Service Information Bulletin

SUBJECT	DATE
Oil Breather Vent	September 2015

Publication Number / Title	Platform	Section Title	Change
DDC-SVC-MAN-0140	DT12	Oil Breather Vent	This is a new section.

d260072

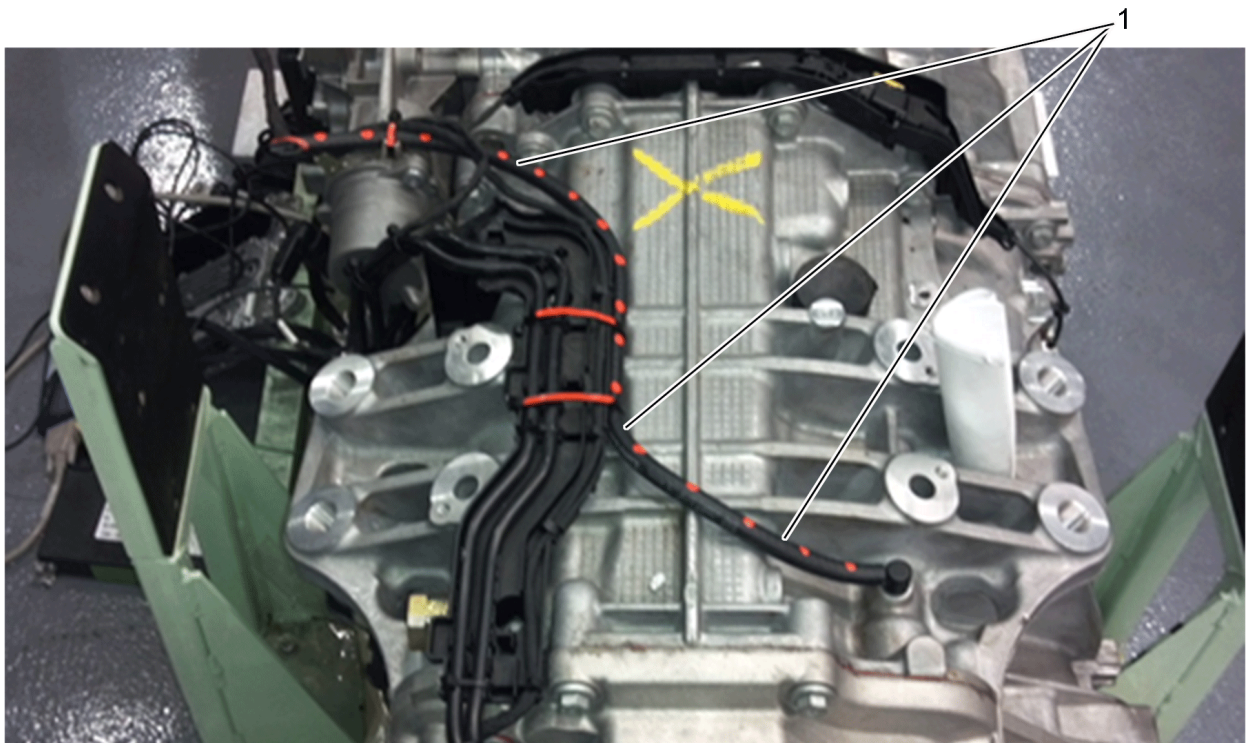
On DT12 DA/OA (large box) transmissions, oil may push out of the breather vent on top of the transmission and run around the outside of the housing to the rear bottom of the transmission. A plastic hose was added to the oil breather vent with approximate transmission serial number 1402497 (last seven digits). However, it is still possible for the plastic hose to leak if the seal to the breather vent fitting is not tight. The oil breather vent and hose were relocated to the left side of the transmission to further reduce the chance of oil leaks with approximate transmission serial number 1614270 (last seven digits).

To repair units with no oil breather vent hose, or a plastic hose on the right side of the transmission, install a ¼" ID hose of a suitable rubber material that is approximately 368 mm (14.5 in.) in length. Run the hose over the top of the transmission to left side front. The hose should end on the left side of the transmission at the AMT module. Secure with zip ties at the three indicated positions (1).
